**OHIO TURNPIKE AND
INFRASTRUCTURE COMMISSION**

ADDENDUM NO. 2
ISSUED FEBRUARY 4, 2020

PROJECT NO. 70-20-01
SLOPE REPAIRS
MILEPOST 132.6 WB
LORAIN COUNTY, OHIO
ISSUED JANUARY 17, 2020

OHIO TURNPIKE		AECOM		OHIO TURNPIKE	
DESIGN AGENCY		BY DATE		REVISIONS	
PROJECT 70-20-01		JEL 11/1/20		NO. 1 Addendum #2	
DATE: 8/28/2019		JEL		ACI	
M.P. 132.6		/IN CHARGE		DSB	
TYPICAL SECTIONS		LORAIN COUNTY		HENRIETTA TOWNSHIP	
8		19		OHIO TURNPIKE

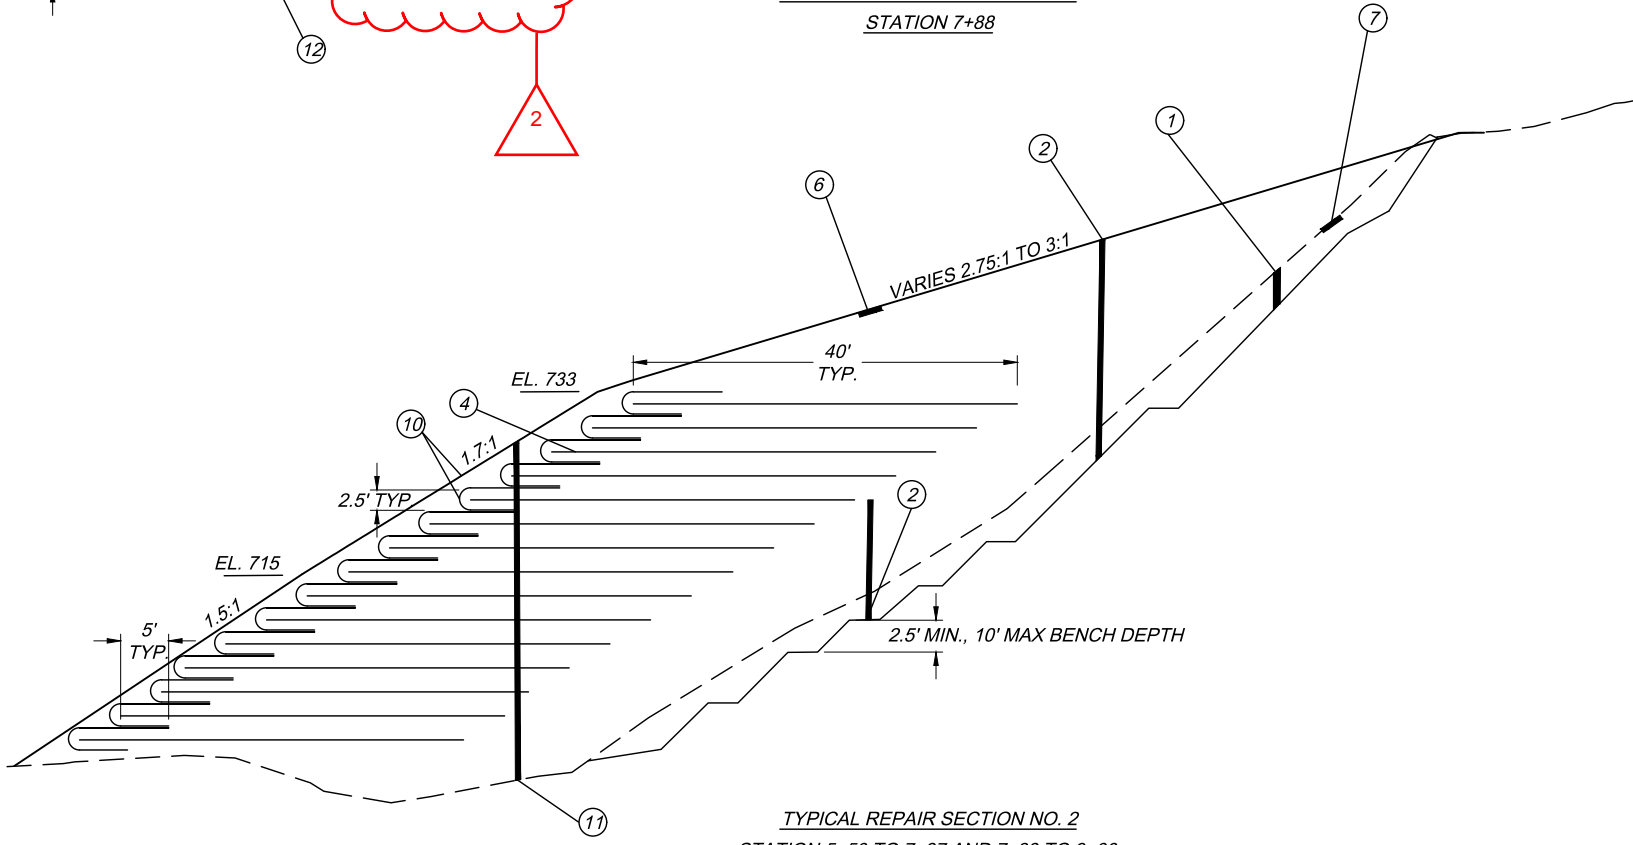
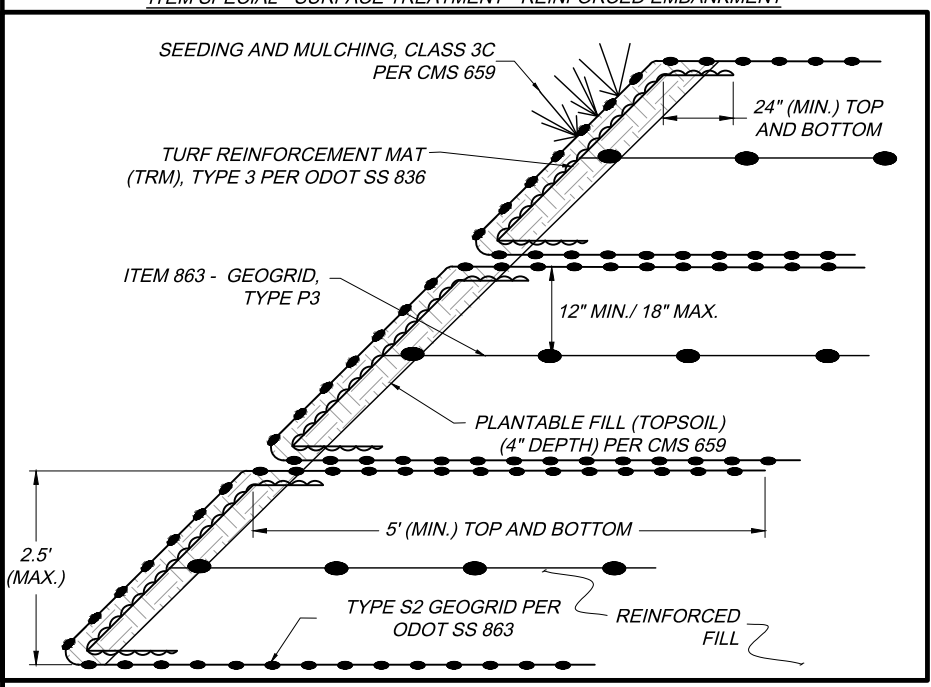
Q#17 Bid item 11- Reinforced Embankment (Granular)- what is the minimum to maximum depth between geogrid in this bid item? Plan sheet shows the range for bid item 10 but not this bid item.

A#17 Vertical spacing and size of geogrids for Reinforced Embankment (Granular) is the same as for Reinforced Embankment – Type P3 grids at 2.5 ft vertical spacing. Typical Sections Plan Sheet 8 of 19 has been revised to include grid depth dimensions. Revised Typical Sections Plan Sheet 8 of 19 is provided with this Addendum No. 2.

FOUNDATION PLAN - PROPOSED HEADWALL AND CULVERT EXTENSION

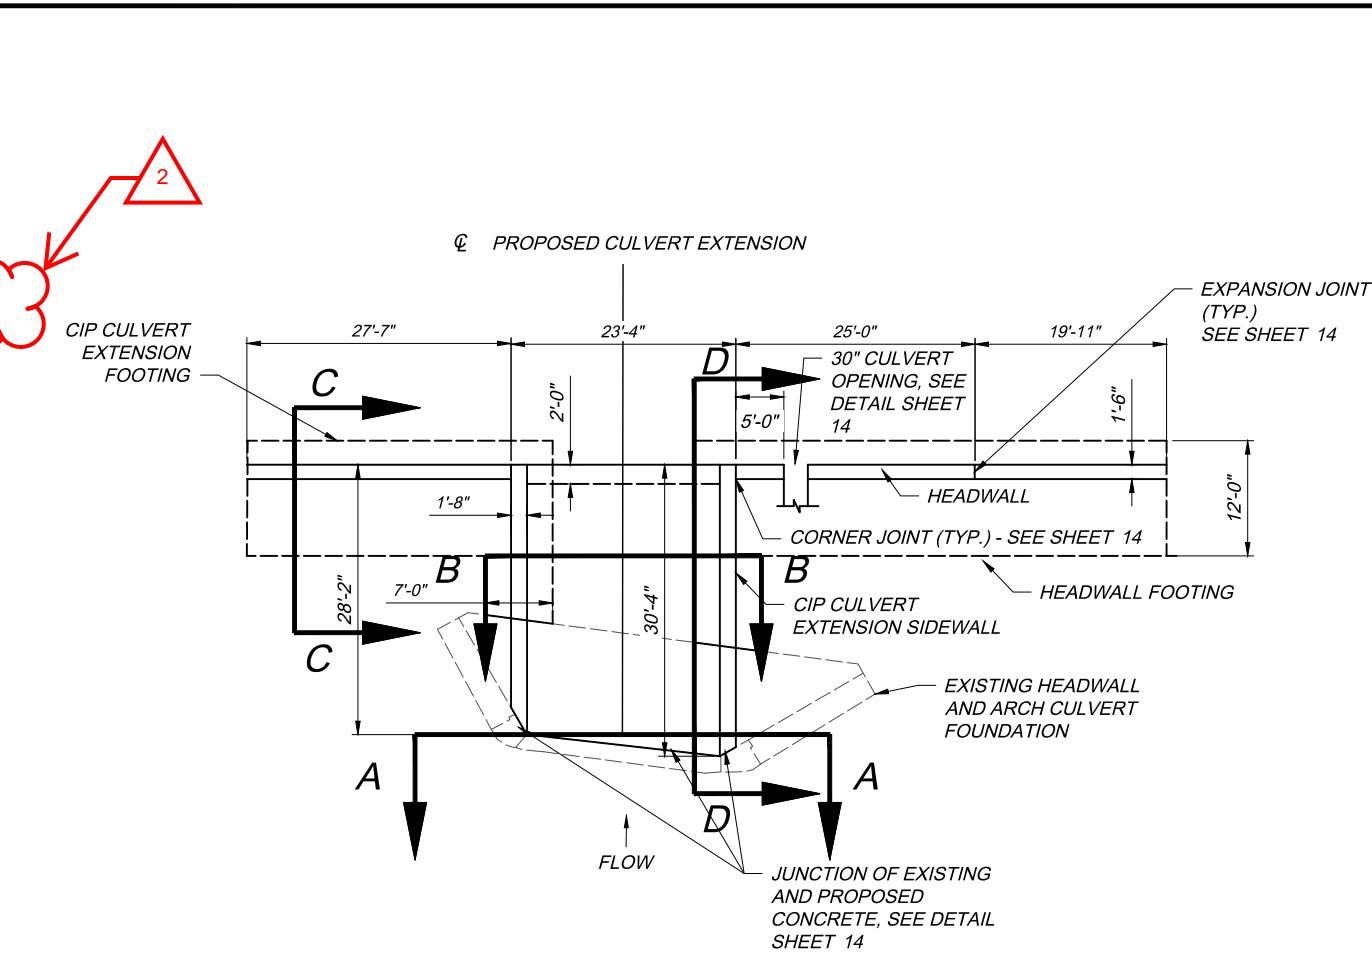
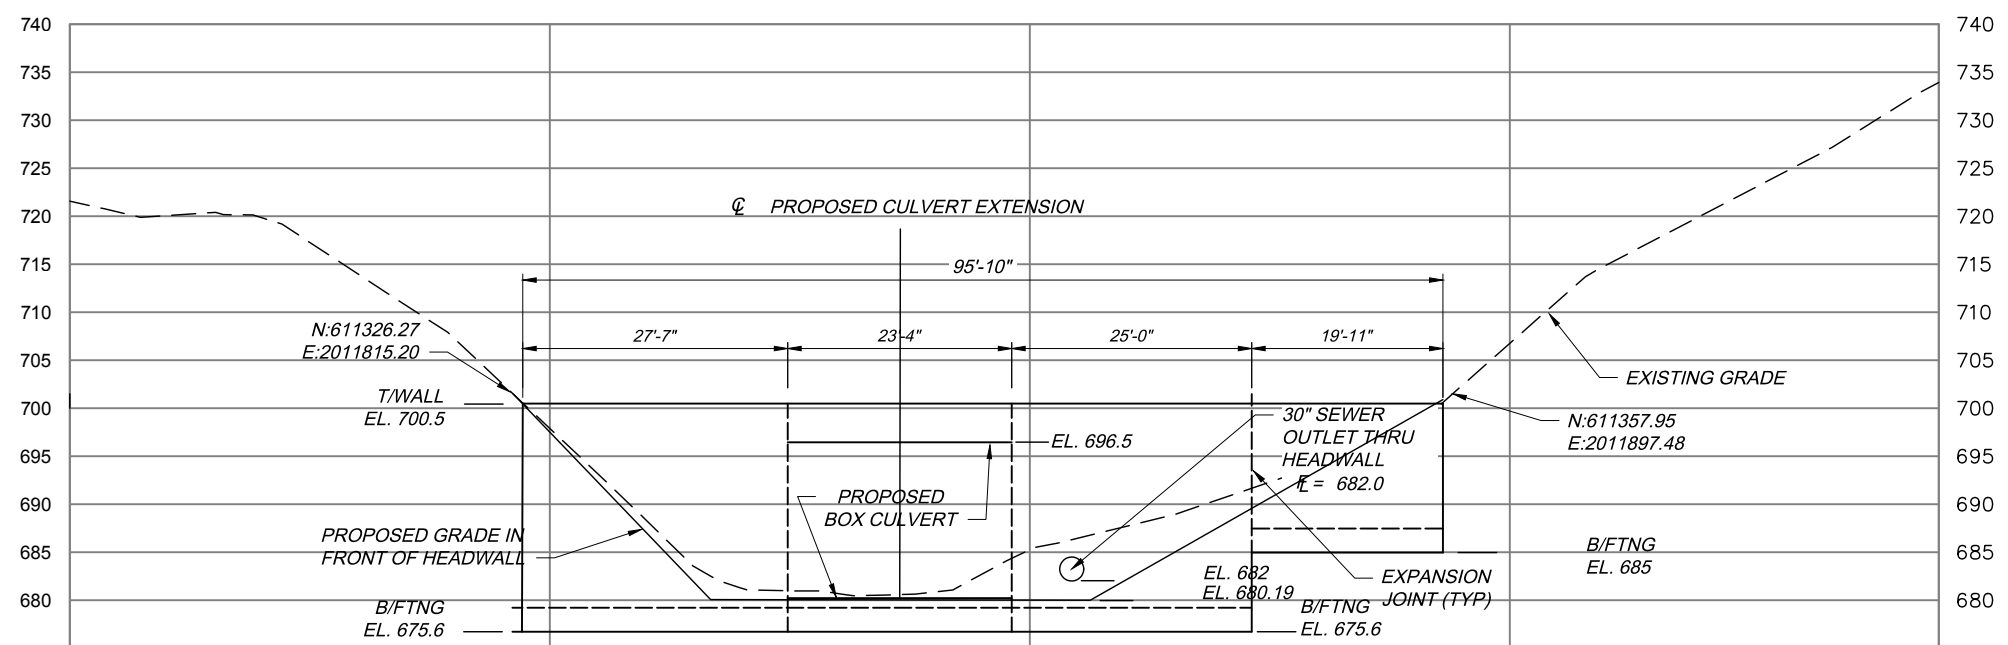
Q#7 Where is the LOW STRENGTH MORTAR BACKFILL, TYPE 2 detailed on plan page 13/19 to be paid?

Q#14 The footing plan on sheet 14/19 shows two large L shaped individual footers, plan sheet 12/19 shows the north east footer to be stepped with bottom of footers at 675.6 and 685.0 which is correct?

A#7 Reference No. 32a, Bid Item 613 - Low Strength Mortar Backfill, Type 2 has been added to the Contract Documents. Additionally, Revised General Summary Plan Sheet 6 of 19, Revised Plan Sheet 12 of 19, the Bid Schedule of Items and the Estimated Quantities Worksheet are provided with this Adeendum No. 2.

SECTION B-B: CULVERT EXTENSION DOWNSTREAM OF EXISTING FOUNDATION

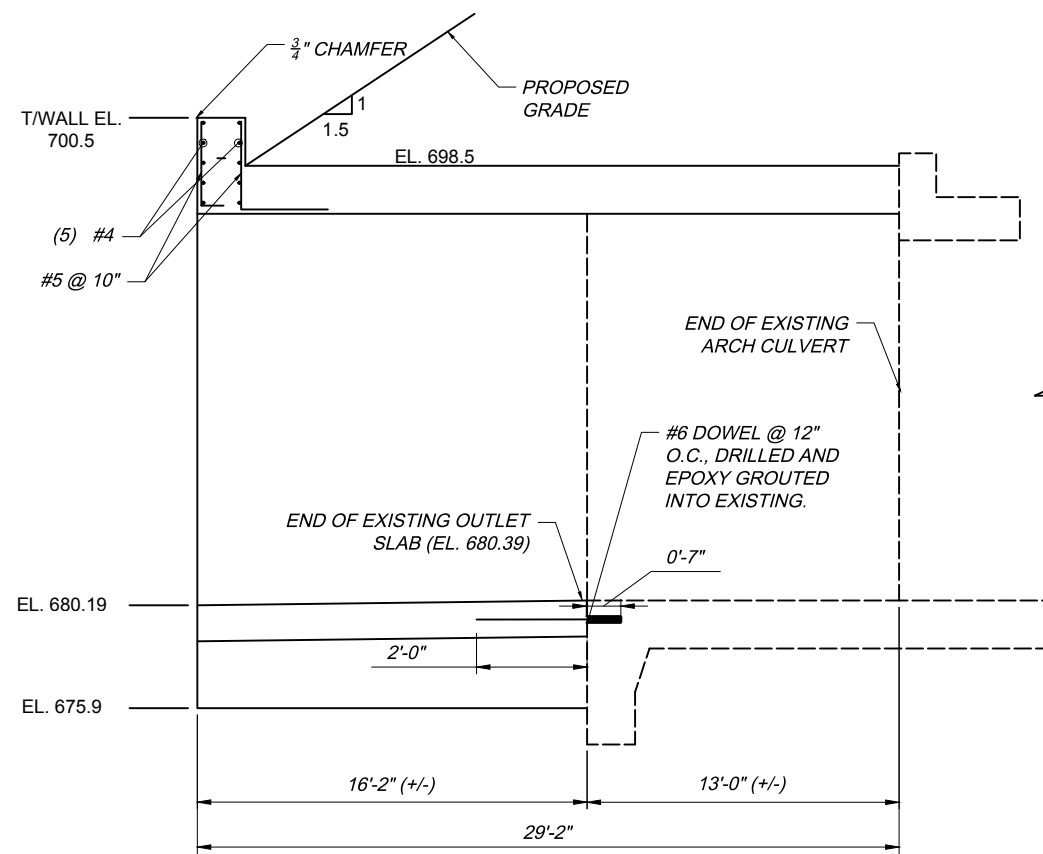
Q#15 Sheet 12/19 shows the bottom of footing elevation as 675.6, sheet 13/19 section B-B shows the bottom footer elevation as 675.9, which is correct?

A#15 The correct elevation is 675.6. The label on “Section B-B” of Structural Details Plan Sheet 13 of 19 has been revised to 675.6. Revised Structural Details Plan Sheet 13 of 19 is provided with this Addendum No. 2.
